**TOWN OF BAY HARBOR ISLANDS
PLANNING AND ZONING BOARD**

June 1, 2021

AGENDA ITEM REPORT

ITEM: Request for approval for a new single family home for “Michael Gad” located at 10130 West Broadview Drive, Lots 45-46 of Block 23. On May 18, 2021 the Board deferred the project. The owner has revised the the plans as requested by the Board. The owner is proposing to construct a new two story single family home. The existing 3,723 sq. ft. single-story home (built in 1951) will be demolished and replace with a new two-story 9,158 sq. ft. home. The residence will have 7 bedrooms, 8 full baths, 1 half bath and a 3 car garage. Enclosed please find the site plan and elevations and a narrative dated May 20, 2021 from the Architect.

SITE PLAN
SCALE: 1/8" = 1'-0"

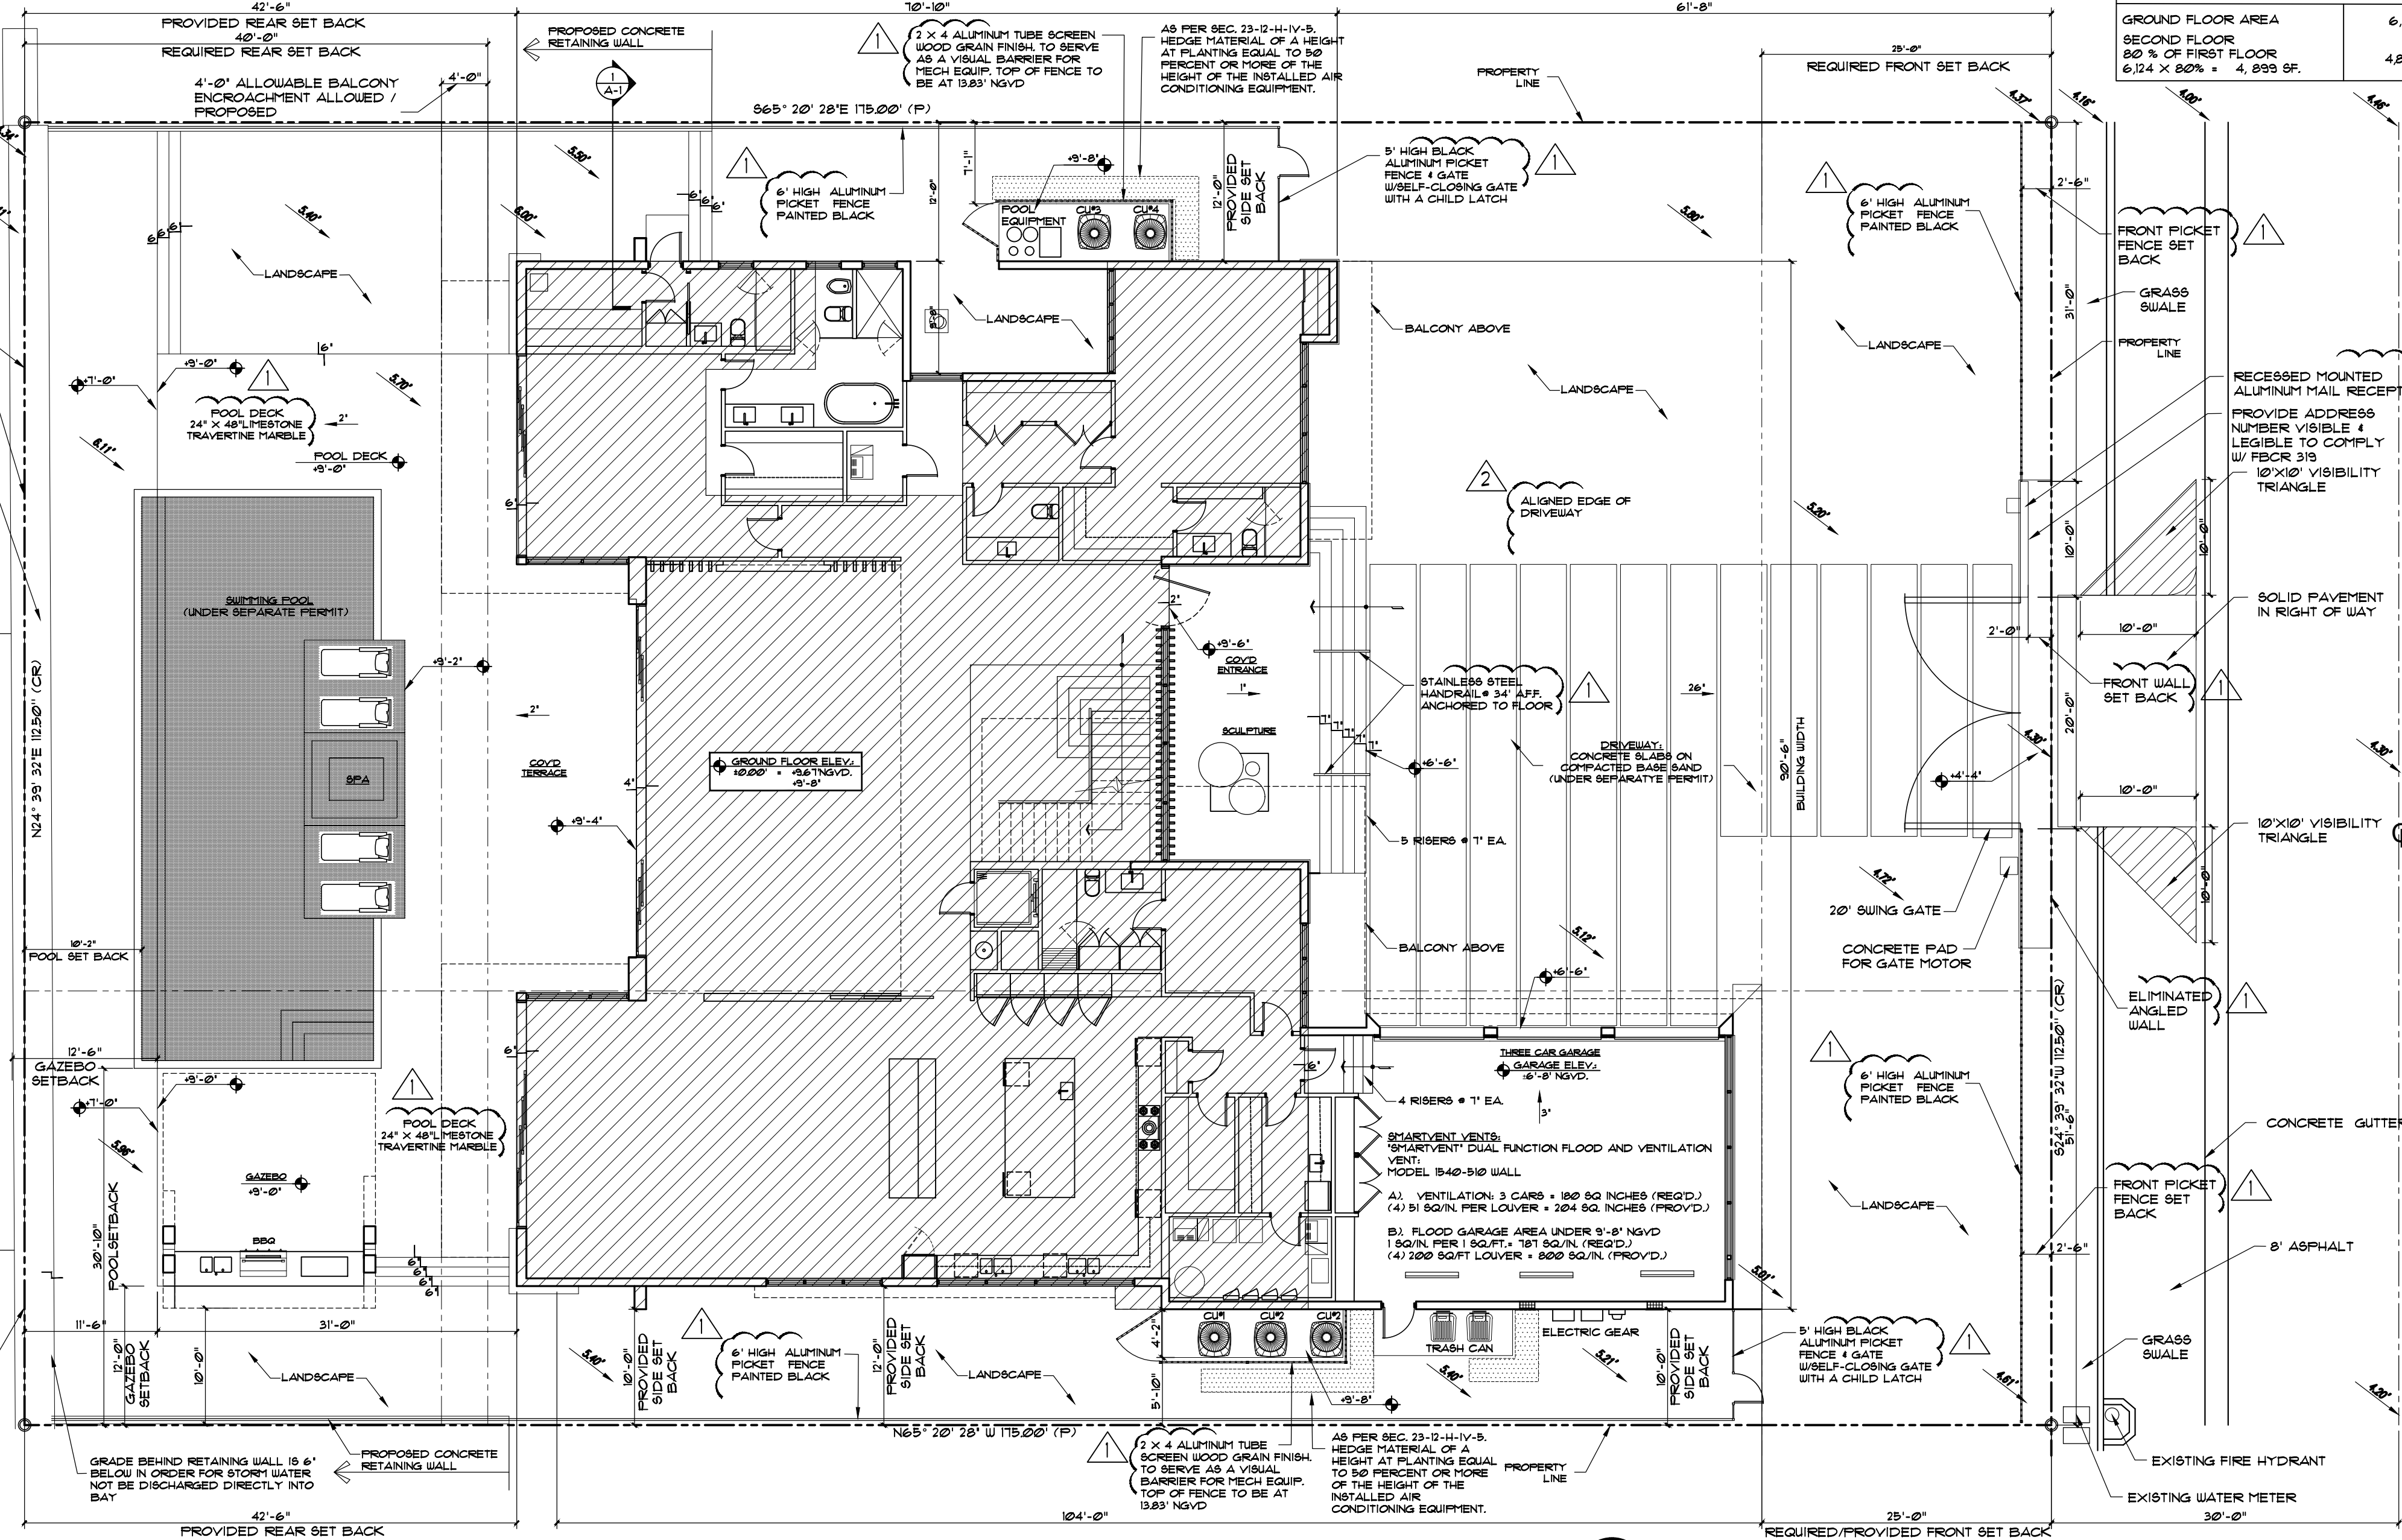
Despite a definitive Code limitation for seawalls designed to protect development and create a uniform seawall height appearance in the Town, the plans have a notation of an intent to raise the seawall cap to 7'-6" NGVD. This will not be allowed and has never been allowed. Town Code Sec. 23-12(10)(c) establishes a minimum / maximum seawall elevation height along Biscayne Bay (and other waterfront areas of the Town). The minimum height is 5.0' MSL (NGVD) and the maximum height allowed is 6.0' MSL (NGVD). Some waterfront landowners have constructed small retaining walls landward of the seawall to assist in occasional wave action (tides / boats). This issue will be addressed as a condition of approval.

- 5) Per Town Code Section 23-12(10)(c) the maximum allowed elevation of any seawall fronting on Biscayne Bay is 6.0' MSL (NGVD). The plans show an intent to construct a seawall / seawall cap at elevation 7'-6" which is strictly prohibited for the reasons stated above. This approval is conditioned on the BP plans being revised to comply with the Code requirements. If the applicant is concerned with flooding / wave action from Biscayne Bay and desires to raise the lot grade, they are encouraged to design / construct a parallel raised wall system landward of the seawall in the rear yard area. This shall not require a PZB approval – Town staff is authorized to review / approve such a wall.

FRONT ELEVATION (SOUTH)
SCALE 3/16" = 1' - 0"

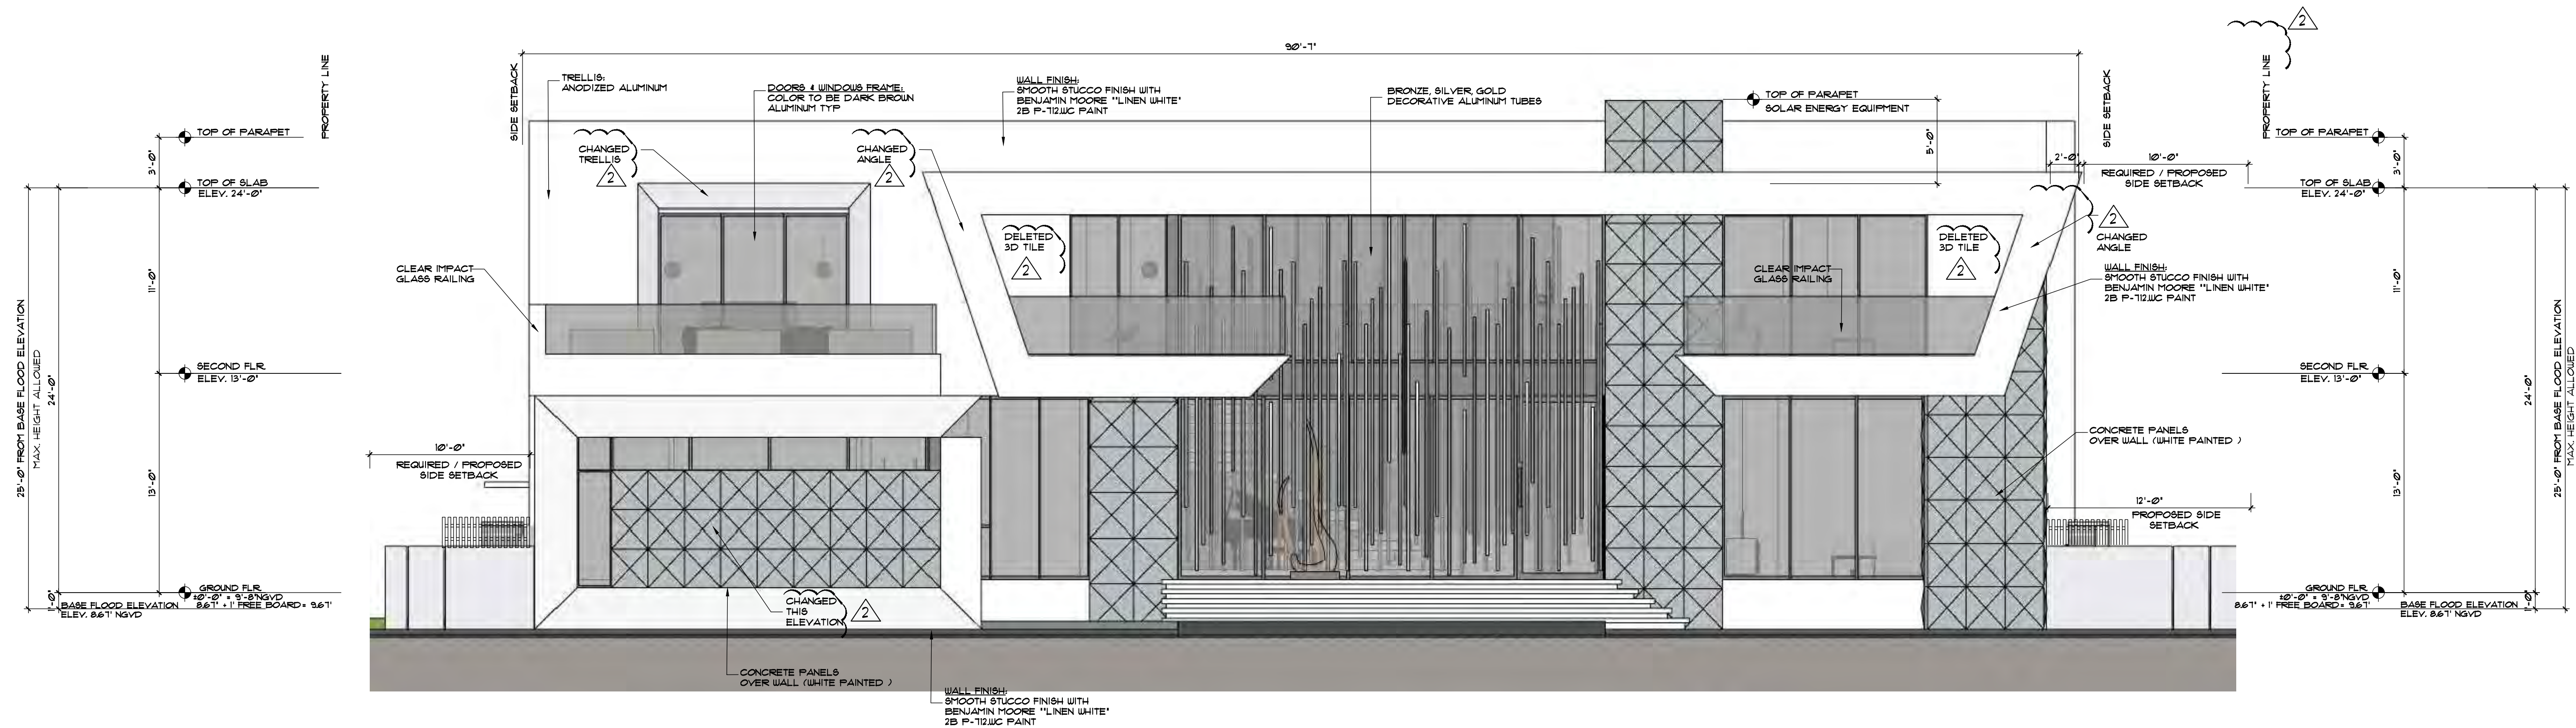
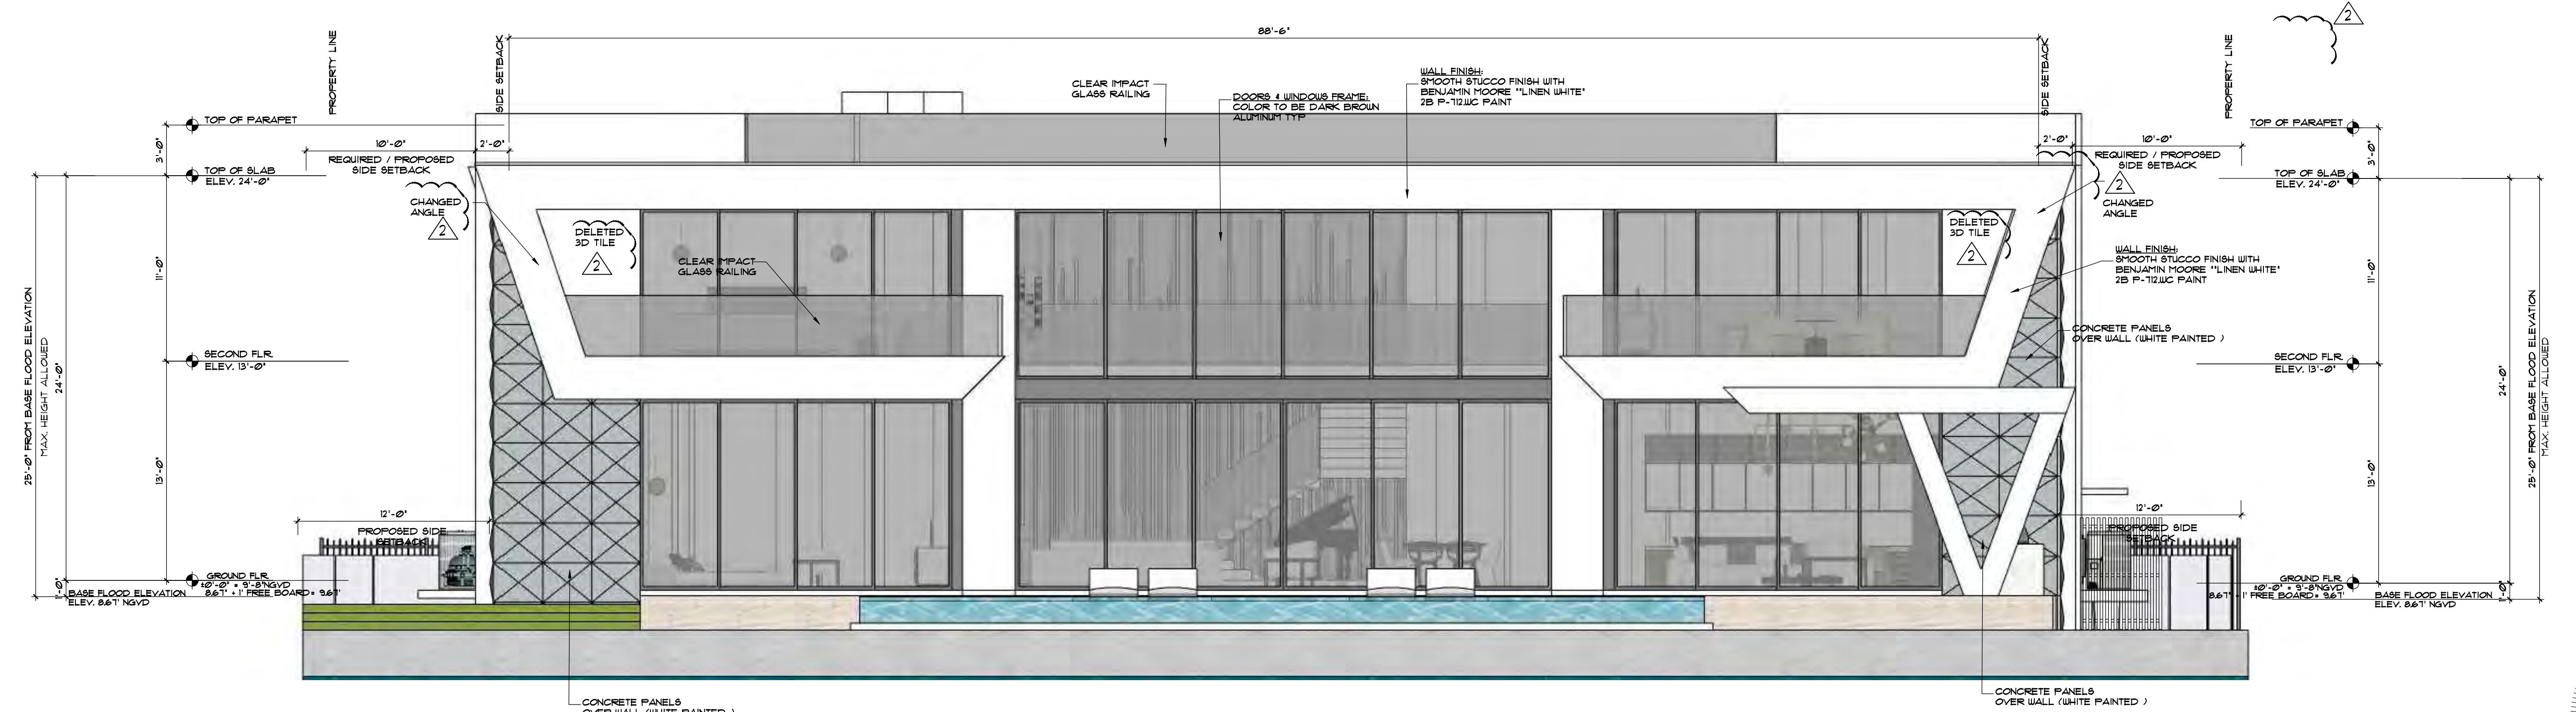
- 1) The angular features shown are too acute. Several PZB members expressed that the angular features should not be as severe as presented. The revised house design includes less acute angles (10% less).

- 2) The front yard privacy fence / entry gate columns that have the same severe angular design should be removed or revised to match the house revisions. The architect offered to remove one of the gate angular columns – shown on the revised plans.

- 3) The garage door color was felt to be too light as shown on the illustrations and not consistent with the overall house color scheme. The architect responded the rendering color was not accurate and should be darker as noted elsewhere on the plans.
